BA52_CP Colay Schematic
Intel Arrandale rPGA-989
PCH BGA 1071
2011-0503
REV :R2.0

modify notice

LVDS Conn w/Camera Module & Int Mic

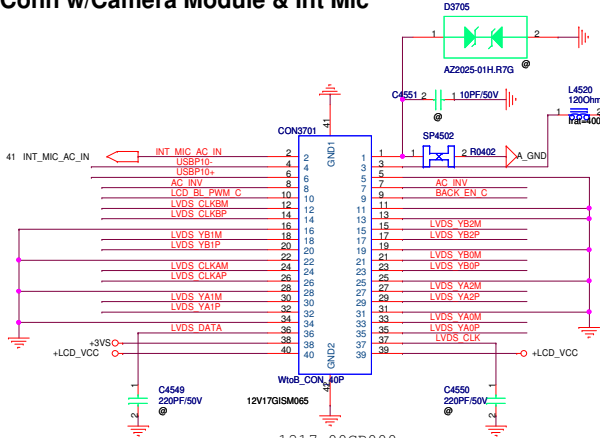
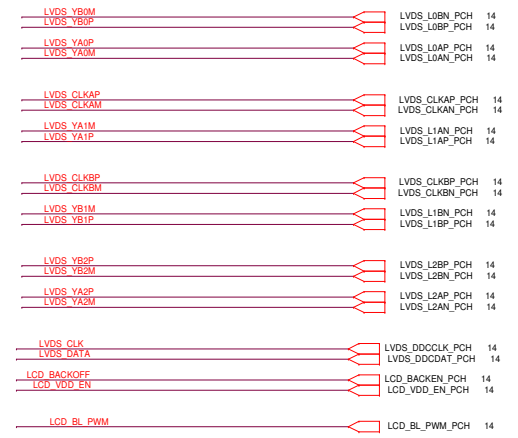
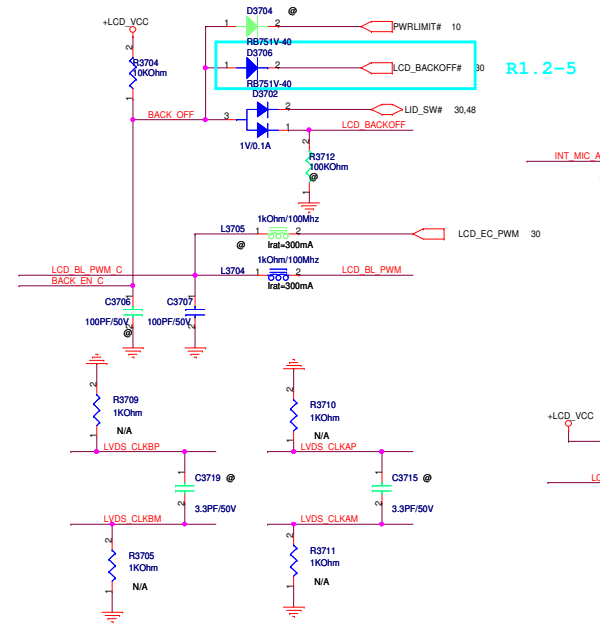
Modify LVDS Pin definition

PEGATRON		Title : <i>Display Port</i>	
BU1-RD Div.1-HW RD Dept.1		Engineer: <i>Elmer Chiu</i>	
Size Custom	Project Name BIC50		Rev 2.0
Date: <i>Tuesday, May 03, 2011</i>		Sheet 40 of 77

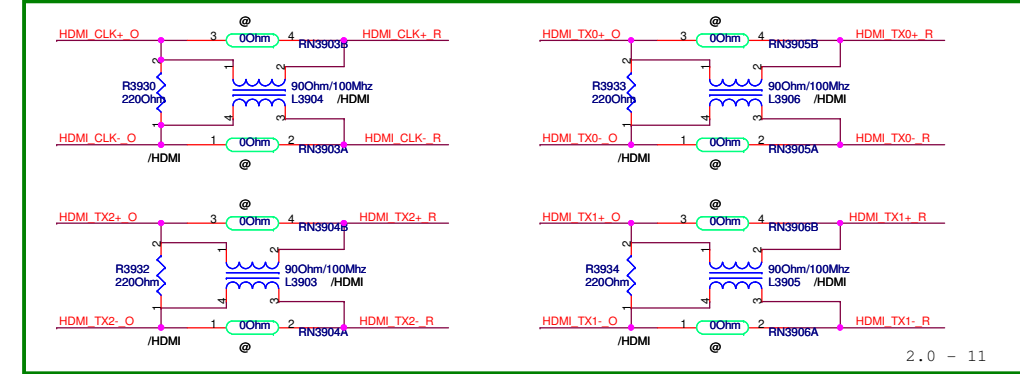
Del F3801, C3811 ADD CRT IN SR-36 0125-11

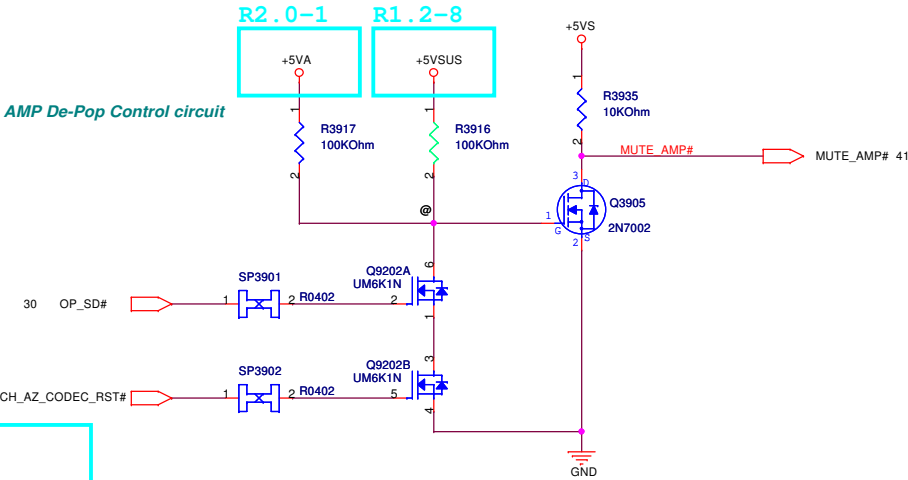
R1.2-6
Change to stereo MIC

PEGATRON		Title : MDC CONN	
BG1-HW RD Dwg.2-NB RD Dept.5		Engineer: Elmer Chiu	
Size	Project Name		Rev
C	BICS0		2.0
Date: Tuesday, May 03, 2011		Sheet	43 of 77

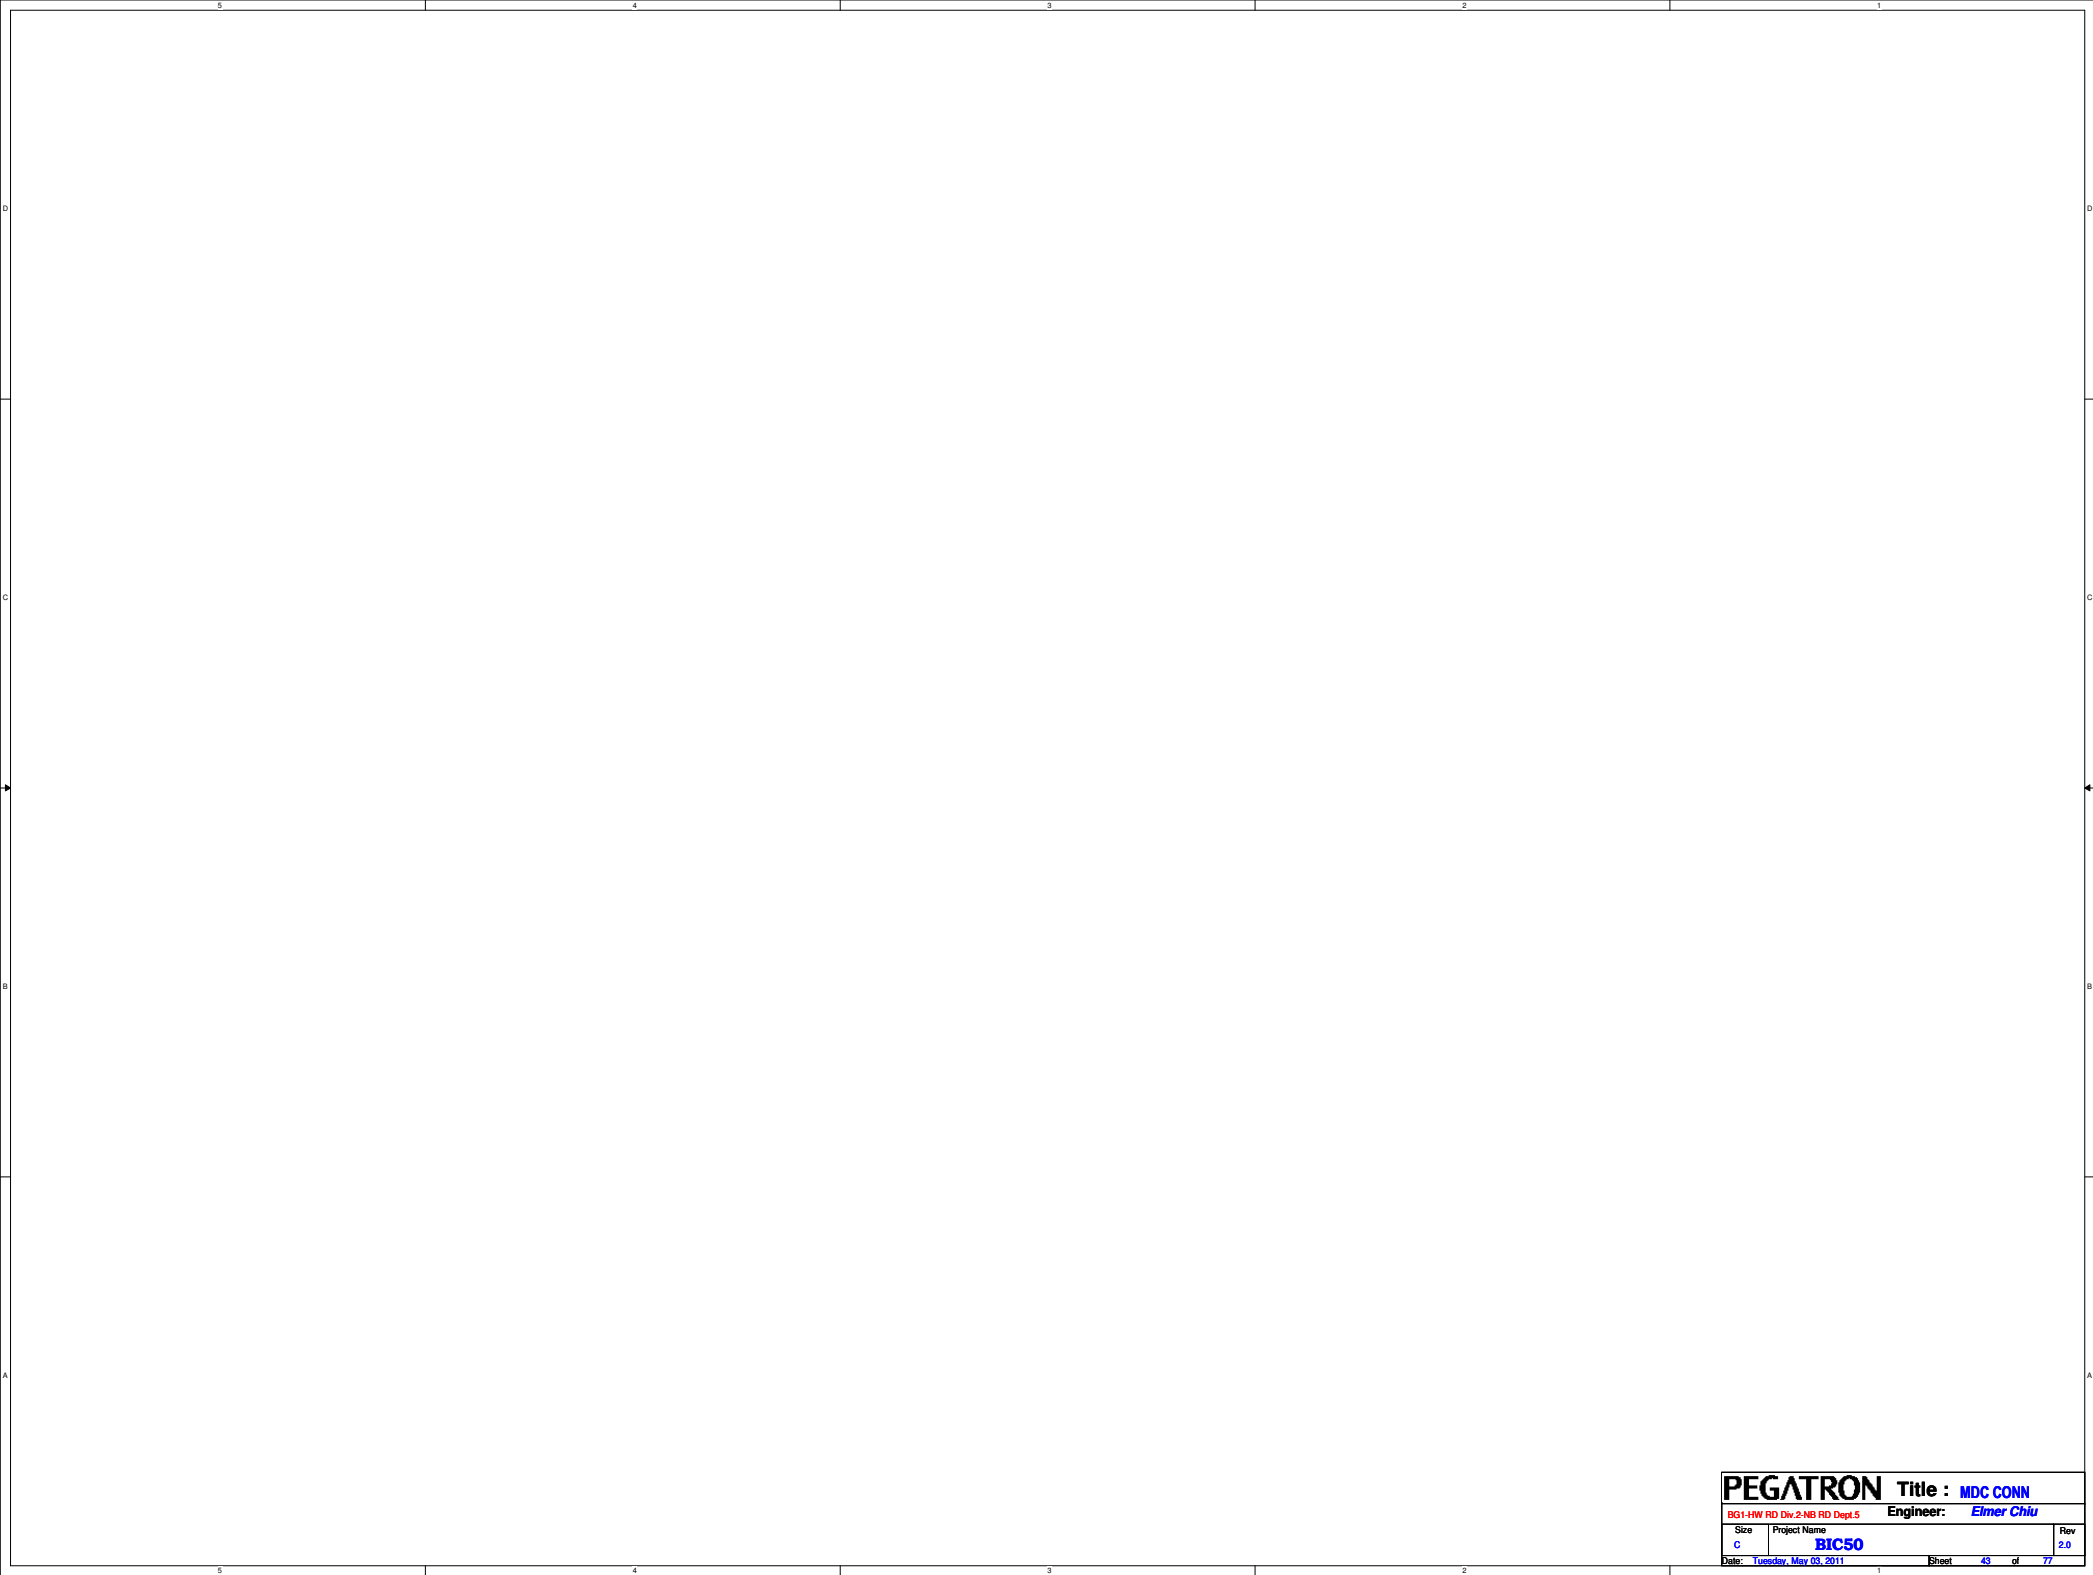
Modify De-Pop circuit
SR-43
0125-11

Touch Pad Button/ Hall Sensor

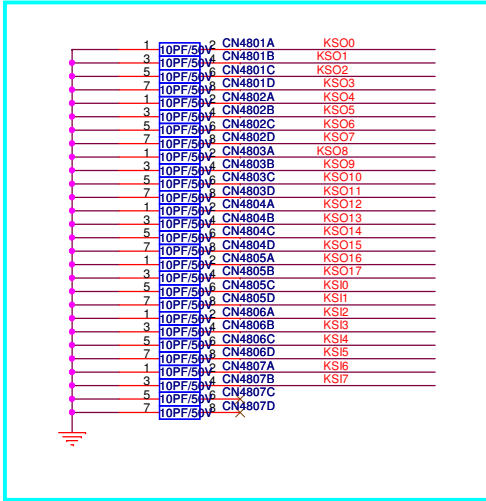
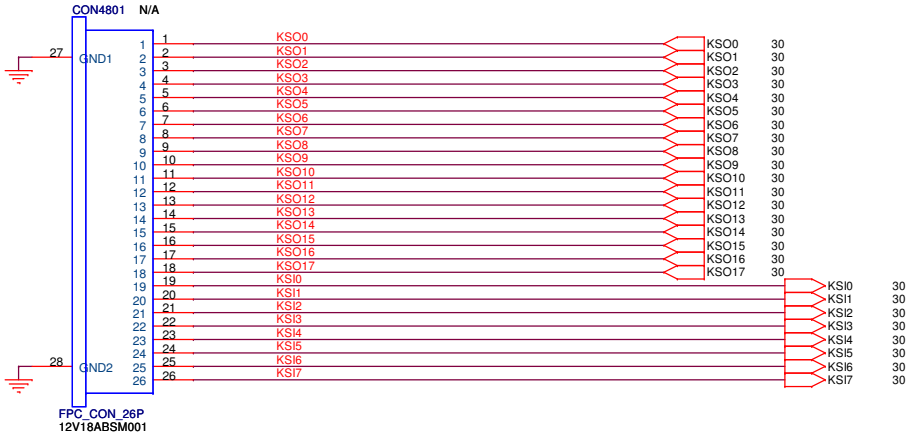
Remove TP button circuit SR=22 0124-11

LED
(Main)

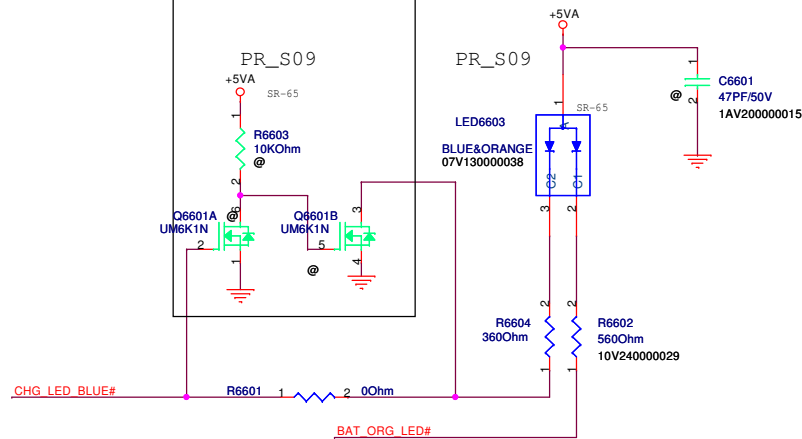
Remover LED circuit^{SR-18}₀₁₂₄₋₁₁

Modify LED circuit	SR-28 0124-11	SR-39 0125-11
--------------------	------------------	------------------

POWER LED 0129

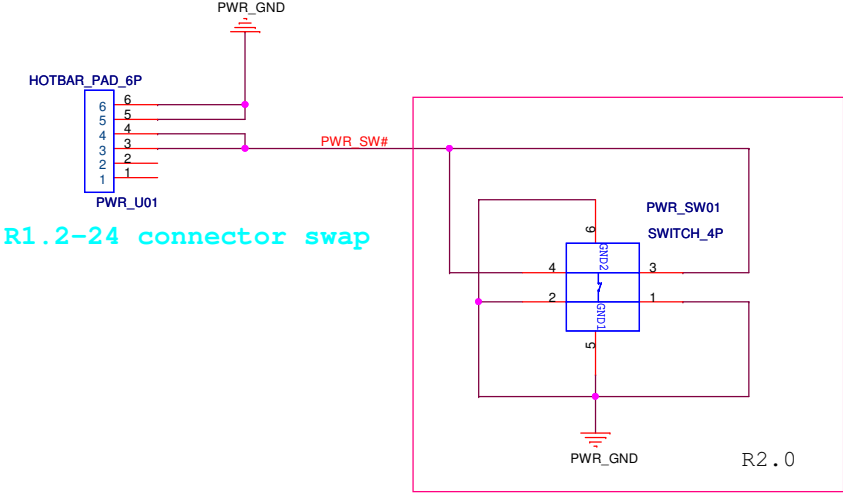
R1.2-24 connector swap
